PH 2022-826
Subdivision Plat
Final Plat and Construction Plans
of the Park Meadows South
Addition, Phase 3

PRELIMINARY PLAT
PARK MEADOWS SOUTH
CITY OF WACO, MCLENNAN COUNTY, TEXAS
FOR REVIEW PURPOSES ONLY

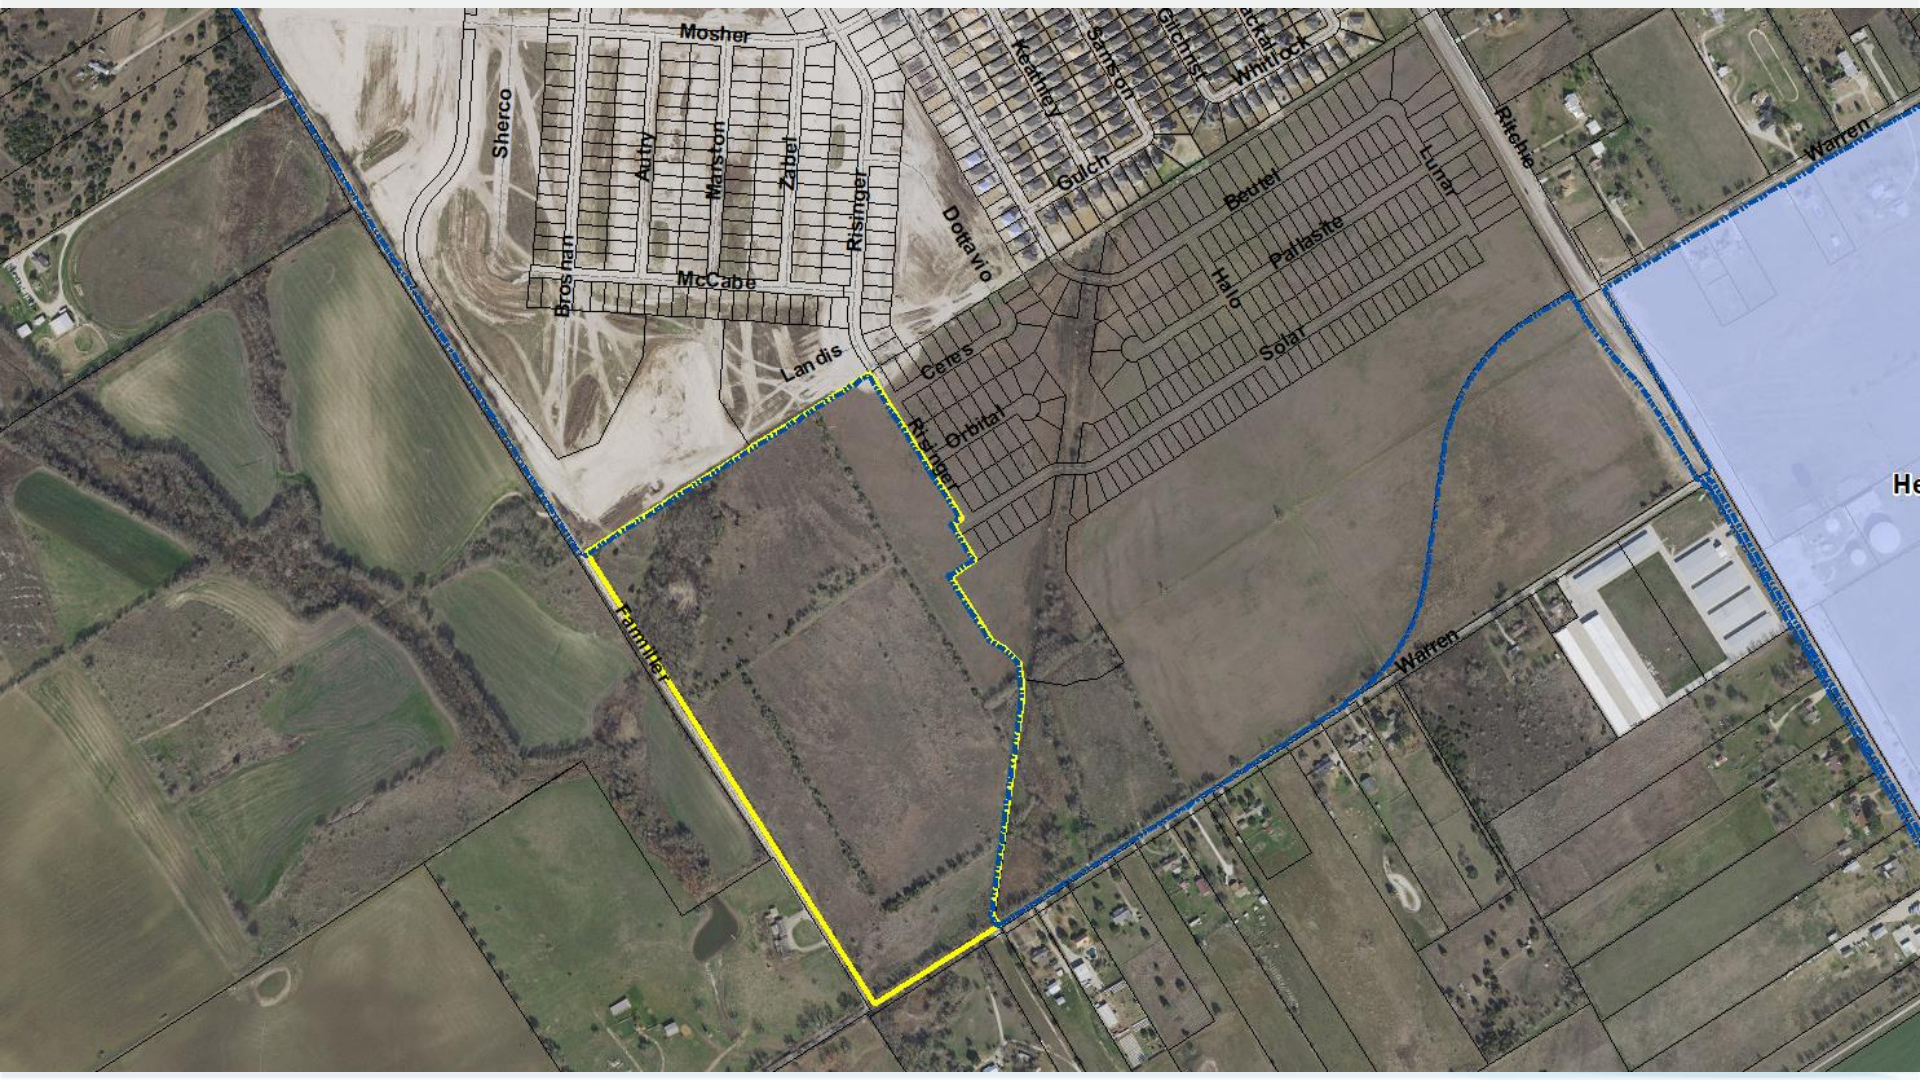
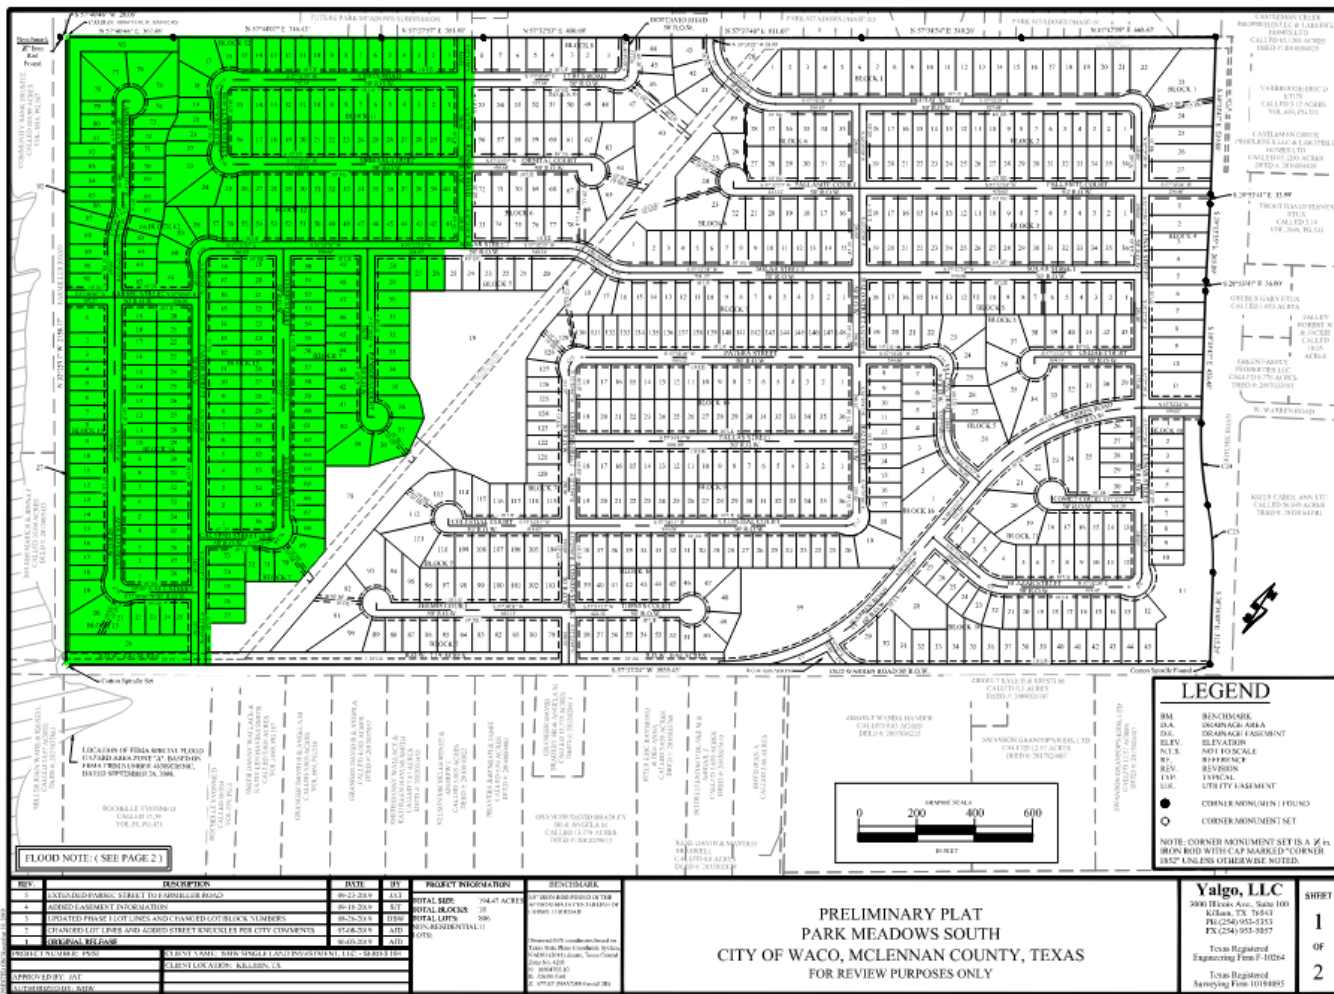
The approved preliminary plat states that Farmiller Road shall be improved prior to platting of the 700th lot or when any connection is made providing regular access from Farmiller Road to the property. This phase of the subdivision will plat 763 lots and connect to Farmiller Road. Therefore, construction plans for Farmiller Road must be submitted, reviewed, approved, and constructed with the infrastructure of this phase. Construction standards for Farmiller Road shall be consistent with the standards included on the preliminary plat and all other applicable City design and construction standards.

Condition has been met with 10/19 resubmittal:
